Access Compliance Report

Public Rights-of-Way

Intersection ID: 10033962	Main Street: PARK_RD	Cross Street: N/A	Location: NW
ADA ID: 61A052435021	Ramp Type: MedianPerp	Initial Pass/Fail: Fail	Overall Compliance: No
Severity Score: 33.75			
Codes/Mitigation Info/Possible Solution		Field Measurements/Component Compliance

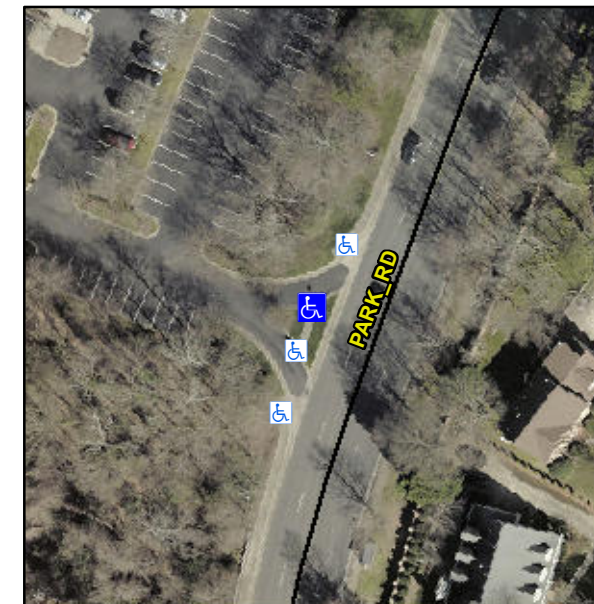
R304.5.1, R304.5.3

Compliance	Description	Data	Compliance	Description	Data
N/A	Ramp Length (in)	40.0	Yes	Ramp Slope (%)	5.9
No	Ramp Width (in)	47.0	No	Ramp XSlope (%)	7.7
N/A	Flare Type LT	N/A	N/A	Flare Type RT	N/A
N/A	Flare Slope LT (%)	N/A	N/A	Flare Slope RT (%)	N/A
N/A	Flare Traversable LT?	N/A	N/A	Flare Traversable RT?	N/A
N/A	Landing Length (in)	N/A	N/A	DWS Provided?	N/A
N/A	Landing Width (in)	N/A	N/A	DWS Contrast?	N/A
N/A	Landing Slope (%)	N/A	N/A	DWS Length (in)	N/A
N/A	Landing X Slope (%)	N/A	N/A	DWS Full Width?	N/A
N/A	Landing Curb? (Y/N)	N/A	N/A	DWS Offset (in)	N/A
N/A	Shared Landing?	N/A			
N/A	Gutter Ponding?	N/A	N/A	Gutter Slope (%)	N/A
N/A	Gutter Lip Ht (in)	N/A	N/A	Gutter X Slope (%)	N/A
N/A	Painted X Walk1?	No	N/A	Painted X Walk2?	N/A
	X Walk 1 Direction	To NE		X Walk 2 Direction	N/A
N/A	X Walk 1 Width (in)	N/A	N/A	X Walk 2 Width (in)	N/A
	X Walk 1 Slope (%)	2.1		X Walk 2 Slope (%)	N/A
	X Walk 1 X Slope (%)	8.1		X Walk 2 X Slope (%)	N/A

Remove & Replace Entire Ramp.
